Access Compliance Report

Public Rights-of-Way

(Curb Ramps)

Intersection ID: 44063	Main Street: SEDGEMOOR_LN	Cross Street: GRAYWELL_LN	Location:	N
ADA ID: 93A8E6E9C2A2	Ramp Type: BlendTrans1	Initial Pass/Fail: Fail	Overall Compliance: No	Severity Score: 42.5

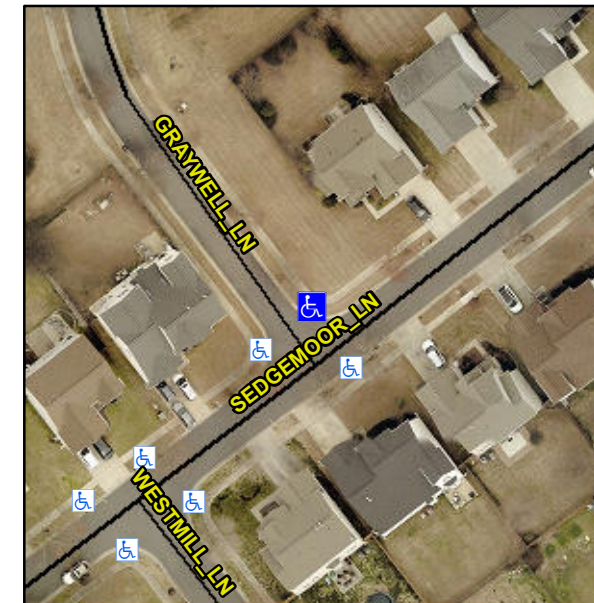
R304.5.1, R304.5.3

Compliance	Description	Data	Compliance	Description	Data
N/A	Ramp Length (in)	71.5	Yes	BlendTrans Slope (%)	3.0
No	Ramp Width (in)	33.5	No	BlendTrans XSlope (%)	7.5
N/A	Flare Type LT	N/A	N/A	Flare Type RT	N/A
N/A	Flare Slope LT (%)	N/A	N/A	Flare Slope RT (%)	N/A
N/A	Flare Traversable LT?	N/A	N/A	Flare Traversable RT?	N/A
N/A	Landing Length (in)	N/A	N/A	DWS Provided?	N/A
N/A	Landing Width (in)	N/A	N/A	DWS Contrast?	N/A
N/A	Landing Slope (%)	N/A	N/A	DWS Length (in)	N/A
N/A	Landing X Slope (%)	N/A	N/A	DWS Full Width?	N/A
N/A	Landing Curb? (Y/N)	N/A	N/A	DWS Offset (in)	N/A
N/A	Shared Landing?	N/A			
N/A	Gutter Ponding?	N/A	N/A	Gutter Slope (%)	N/A
N/A	Gutter Lip Ht (in)	N/A	N/A	Gutter X Slope (%)	N/A
N/A	Painted X Walk1?	No	N/A	Painted X Walk2?	No
	X Walk 1 Direction	To SW		X Walk 2 Direction	To SE
	X Walk 1 Width (in)	N/A		X Walk 2 Width (in)	N/A
	X Walk 1 Slope (%)	2.1		X Walk 2 Slope (%)	4.4
	X Walk 1 X Slope (%)	4.9		X Walk 2 X Slope (%)	2.8

Remove & Replace Curb Ramp With Two New Directional Ramps or Equivalent.
